Subject: PA-2021-062, 2164 Palm Ave., Pre App  
2164 Palm Ave., APN 039-073-510

## Le Court Rouge - Enlarged Partial Ground Floor Plan - A.6 Sidewalk Standard

2164 Palm Ave, San Mateo CA  
scale: 1/8"=1'-0"  
Swatt | Miers Architects  
11/30/21

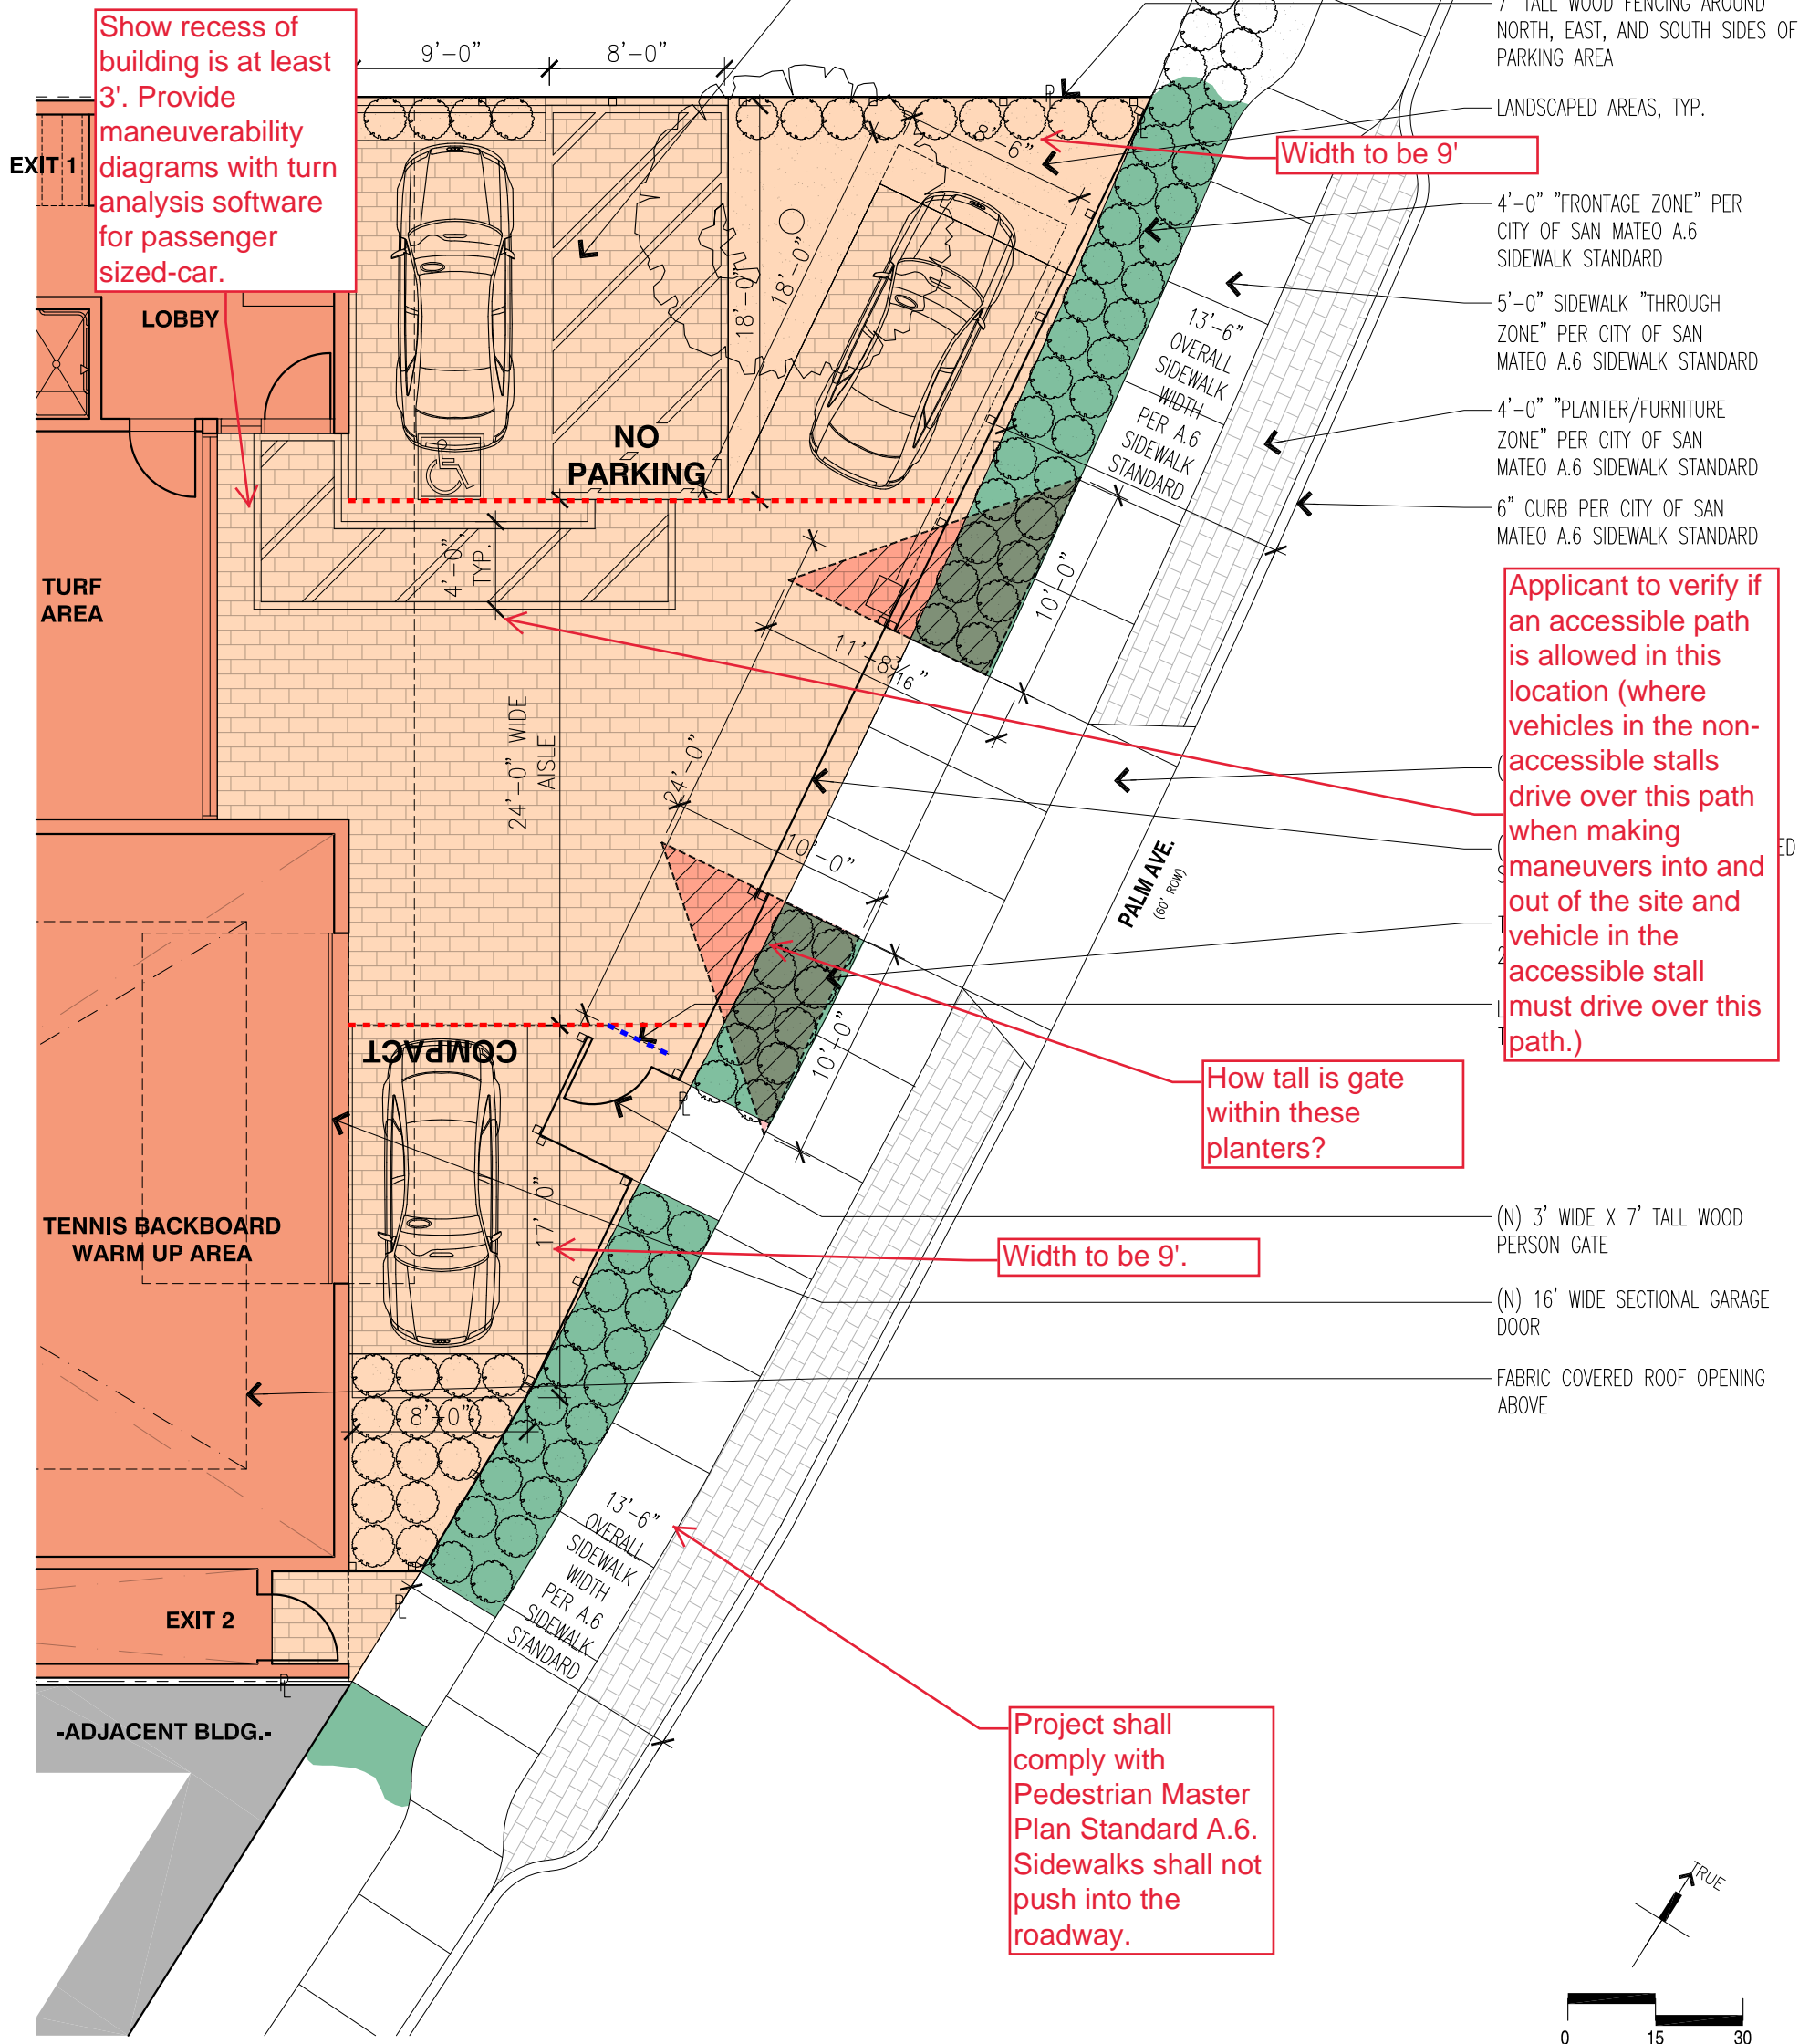
- Vehicles must be able to maneuver on-site such that they are able to:

(b) Exit the site driving forwards after having executed no more than a two-point turn.

- Number of parking stalls and layout dependent on Parking Study in Formal Planning Application.
